**\*MANDATORY SERVICE BULLETIN\*****NUMBER:** SB-018**REVISION:** A**DATE:** 7/31/2009**SUBJECT:** FUEL SYSTEM; MANDATORY CHAFE PROTECTION ADDITION TO MAIN CABIN FUEL LINES**SUMMARY****RECURRENT REQUIREMENTS**

**FUEL SYSTEM; Mandatory Chafe Protection  
Addition to Main Cabin Fuel Lines**

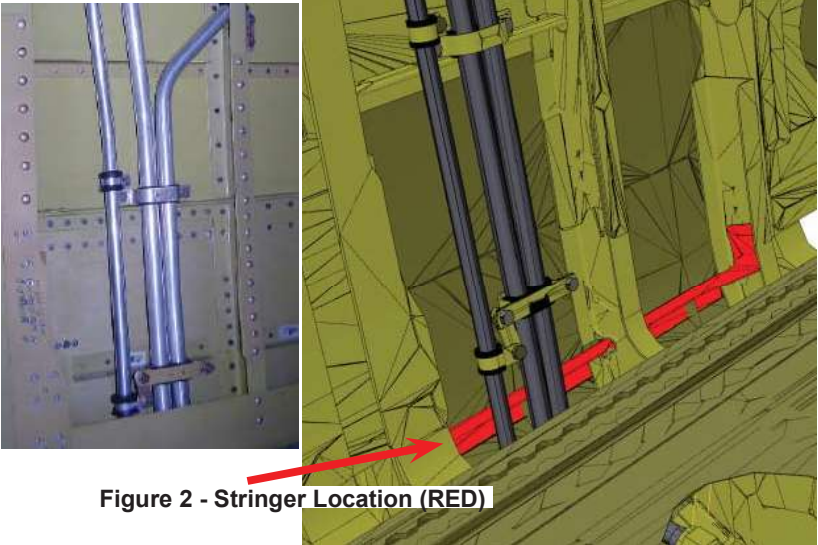
Task	Instruction	Instruction
4	<p>Irrespective of evidence of chafing, chafe protection shall be installed. Cut a piece of CAT Track™ 6 inches long and install on the stringer at the fuel lines as shown.</p>	
7	<p>Reinstall the insulation. Plug in the heaters and head phone jacks. Install the side panels in accordance with the KODIAK 100 Maintenance Manual.</p>	
8	<p>Repeat steps 1-7 on the opposite side of the fuselage.</p>	
9	<p>Note the work performed in the KODIAK 100 Log Books.</p>
